DRAINAGE LETTER

ROLLING THUNDER BUSINESS PARK FILLING NO. 2

A REPLAT OF LOTS 2 AND 3, ROLLING THUNDER BUSINESS PARK

SUBJECT: Drainage Letter
Rolling Thunder Business Park, Filing No. 2

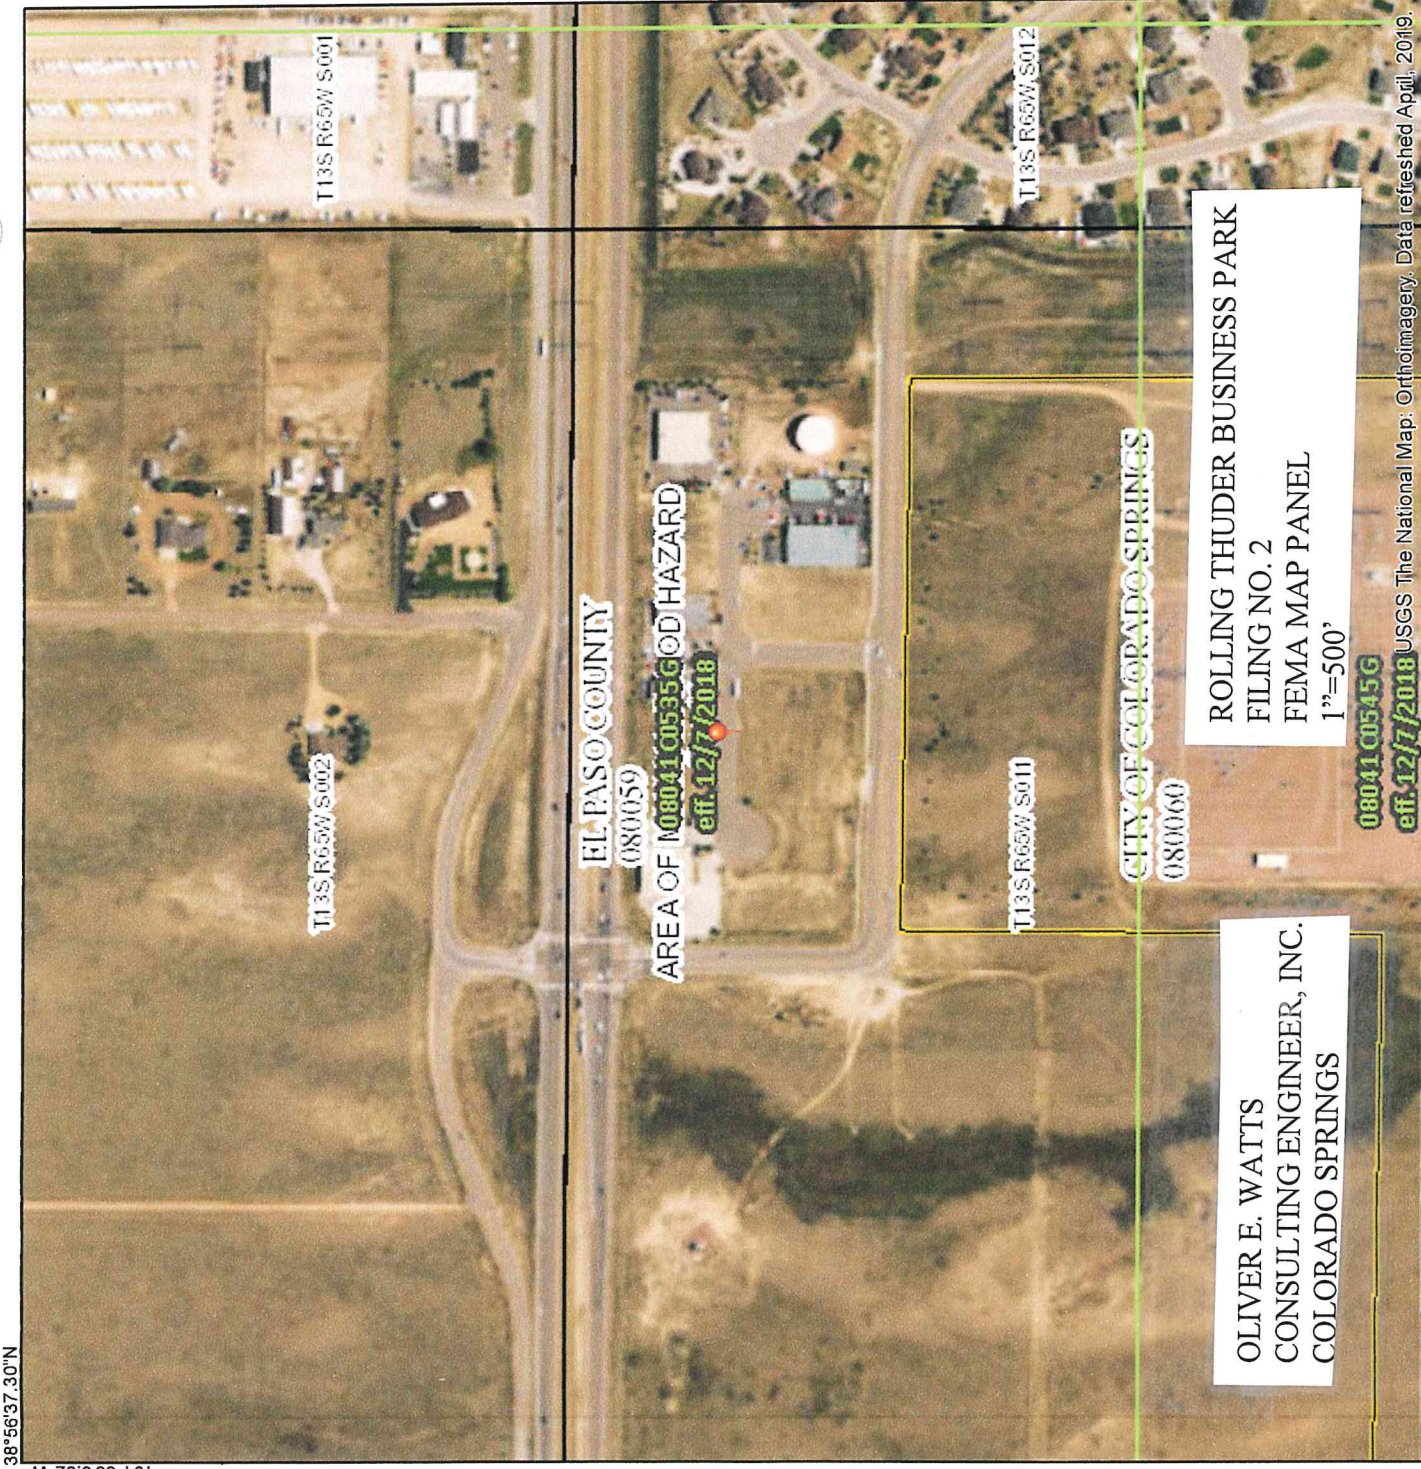
Please show how you calculated your coefficients for basins A & B. It appears that the majority of these basins are pavement and roof (100% & 90% impervious)

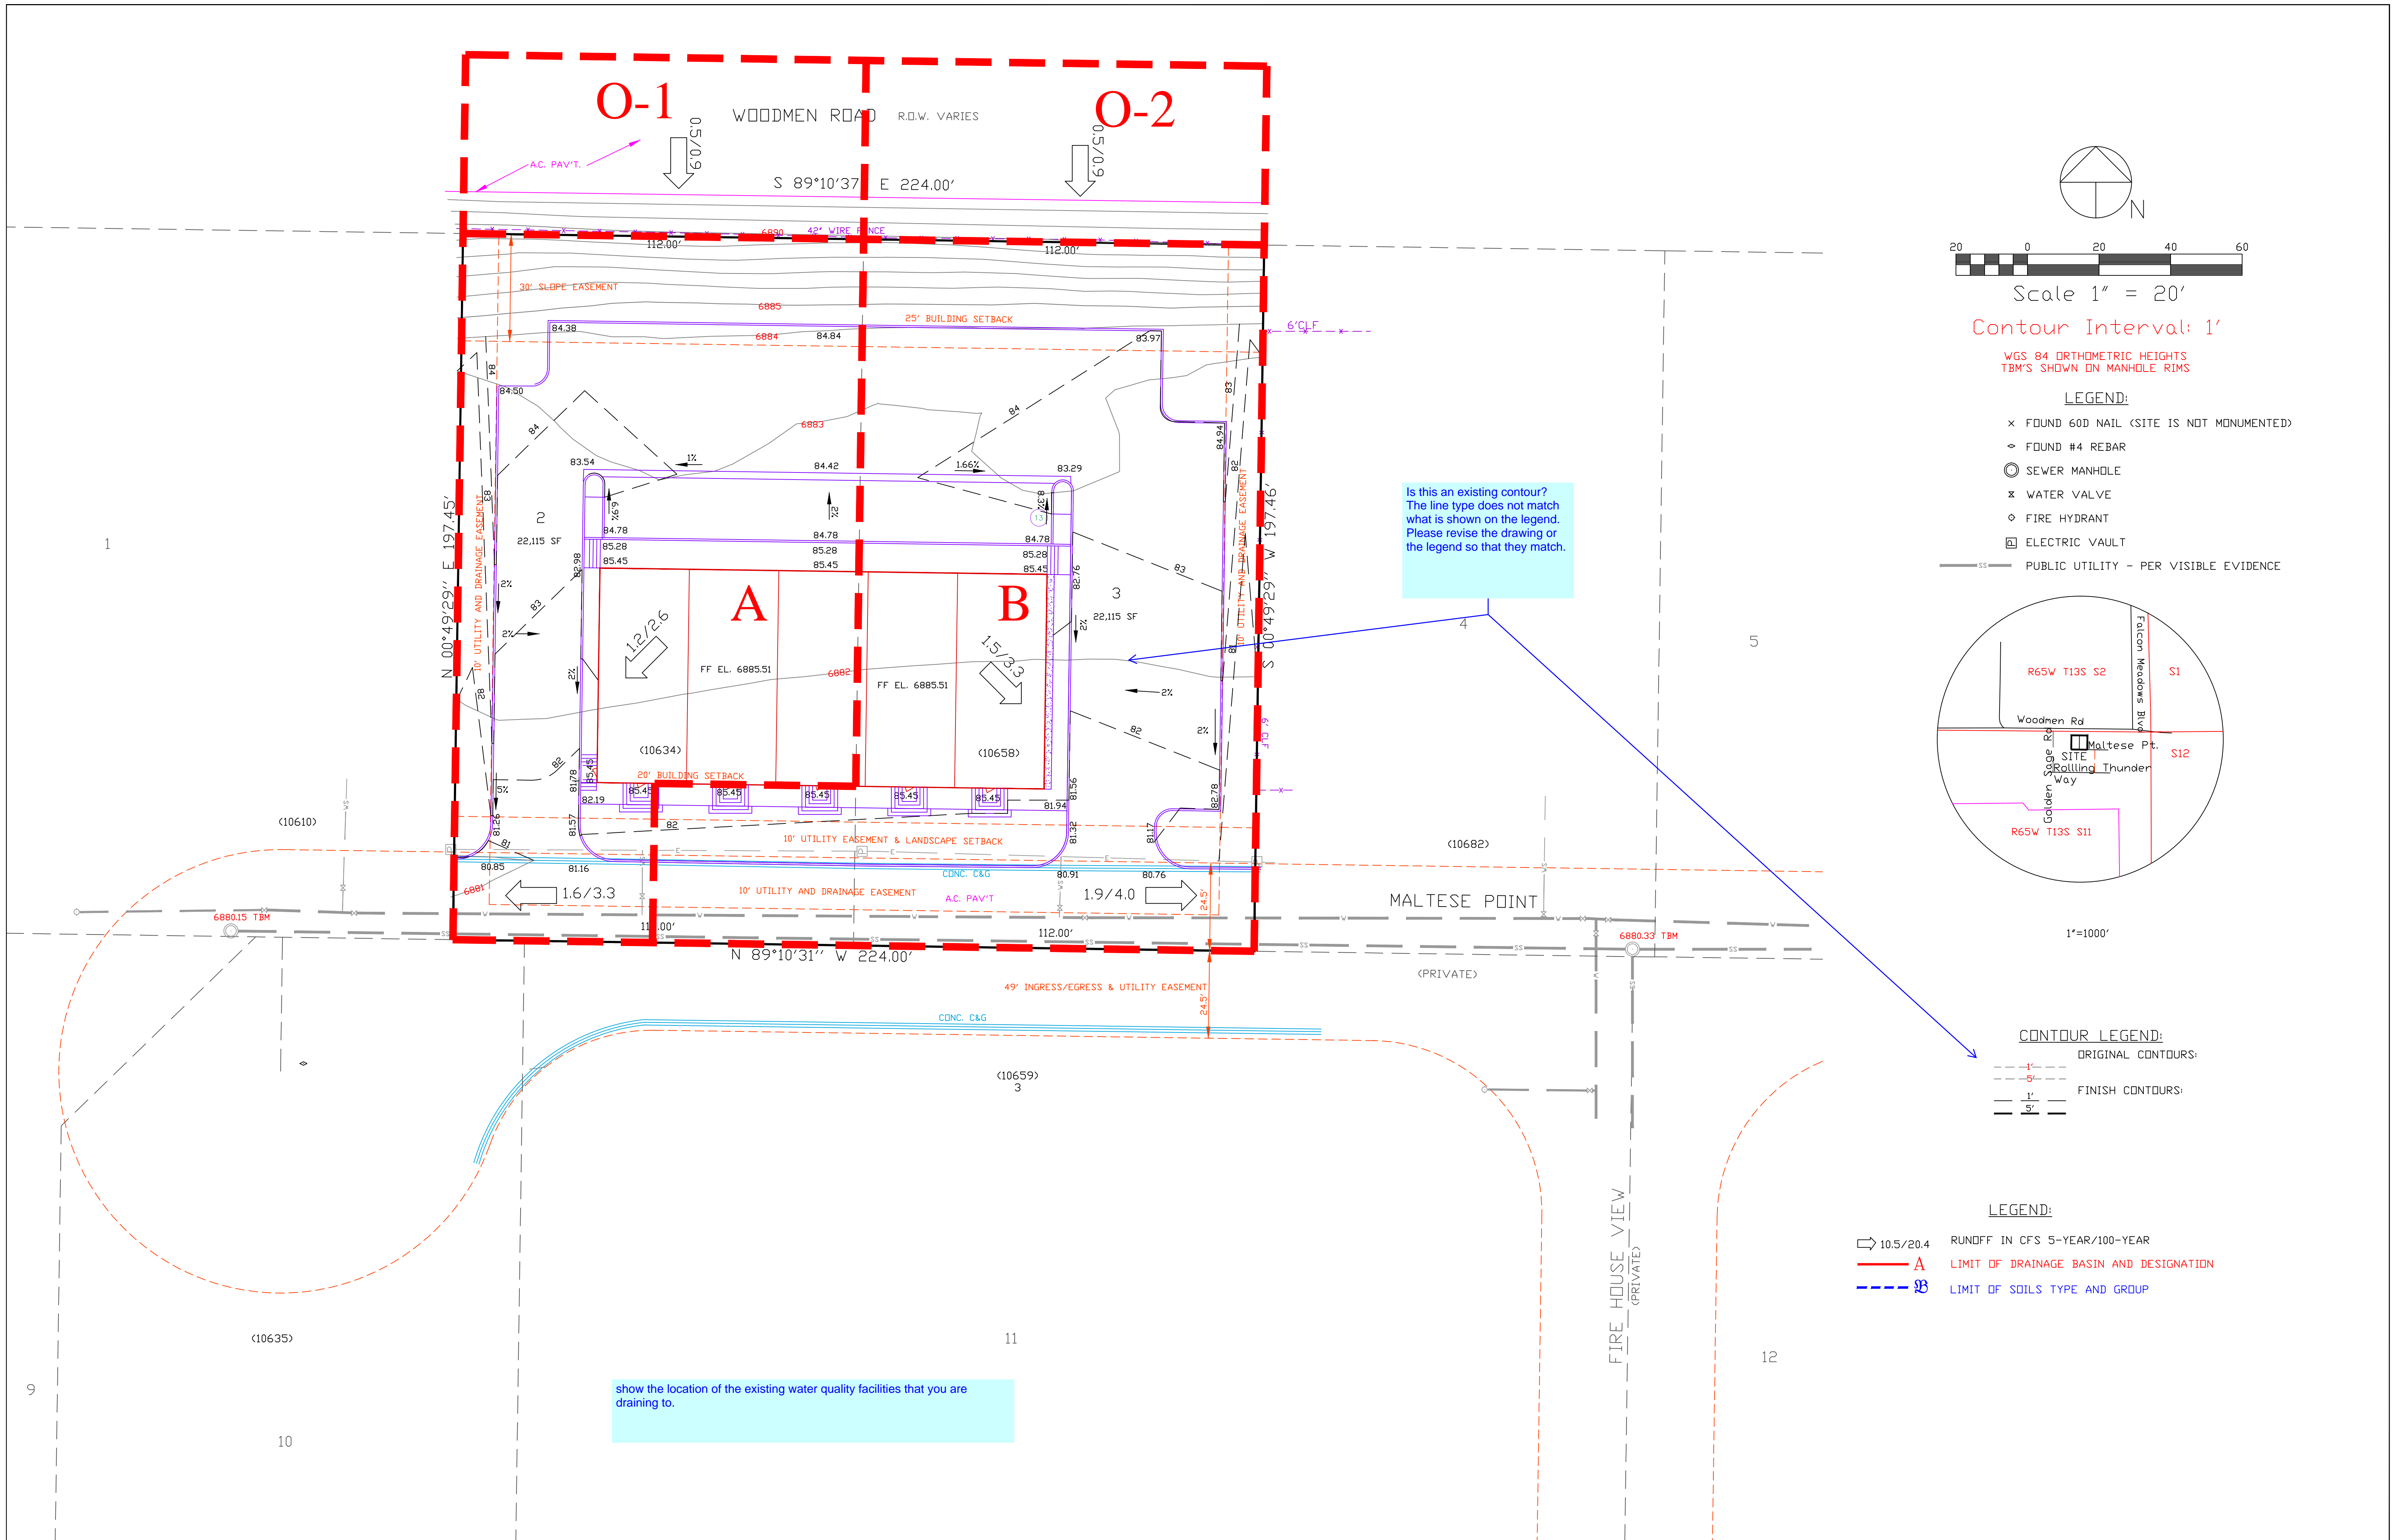
show the location of the existing water quality facilities that you are draining to.

Is this an existing contour?
 The line type does not match
 what is shown on the legend.
 Please revise the drawing or
 the legend so that they match.
